**Synapse Real Estate Corp  
Synapse Data Center Power Plant Project  
Proceeding 30732  
Application 30732-A001**

**Synapse Real Estate Corp ("Synapse") Response to  
Alberta Utilities Commission ("AUC") Information Request ("IR") No. 1**

**Synapse-AUC-2026MAY14-001**

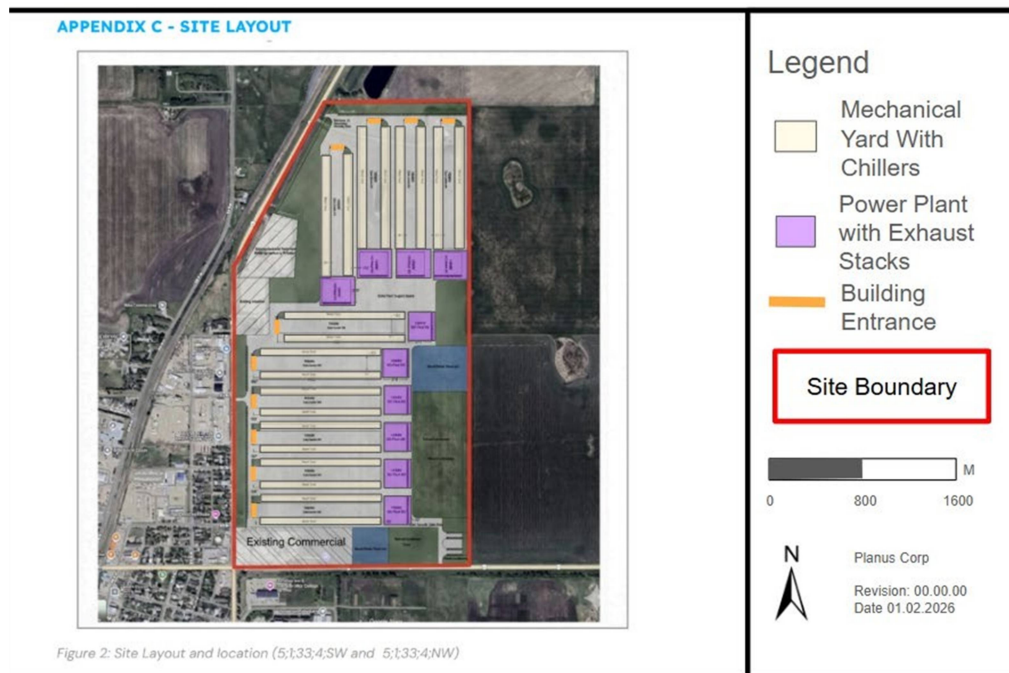
**Preamble:** The figure in Exhibit 30732-X0018, PDF page 8, depicts the location of the emergency backup generators within the mech yard. The figures in Exhibit 30732-X0018, PDF page 7 and Exhibit 30732-X0013, PDF page 6 appear to depict a modular design with each unit block separate. Exhibit 30732-X0013, PDF page 7 appears to depict a single large, enclosed warehouse structure.

- Request:**
- (a) Is the mech yard enclosed or open and exposed?
  - (b) Where is the building entrance, as depicted in Exhibit 30732-X0013, PDF page 7, located in the site layout on PDF page 6?
  - (c) Please identify where the chillers and exhaust stacks are depicted in Exhibit 30732-X0013, PDF page 7.
  - (d) Identify whether the data centre and power plant are contained in a single cover structure or a more modular design. If it is the latter, confirm whether more representative drawings have been provided in the consultation material and provide a copy.
  - (e) If a more representative drawing of the completed project is not part of the consultation material, please submit a drawing or photos of real-world examples.

**Response:** (a) The mechanical yard is open to the atmosphere and is not enclosed within a building structure.

The mechanical yard is designed with acoustical mitigation features, including sound attenuation walls and equipment layout considerations to assist in meeting the facility's noise design criteria and applicable property-line sound requirements. These structures are intended to reduce off-site noise propagation while maintaining access for equipment operation, maintenance, ventilation, and safety.

The figures referenced in Project application materials represent conceptual design illustrations prepared at different stages of Project development. The final site layout consists of enclosed buildings for the data center and certain

plant equipment, together with outdoor mechanical yard areas that remain open to the atmosphere but incorporate sound attenuation measures as part of the overall facility design. The sound attenuation walls should not be interpreted as building walls or a fully enclosed structure.
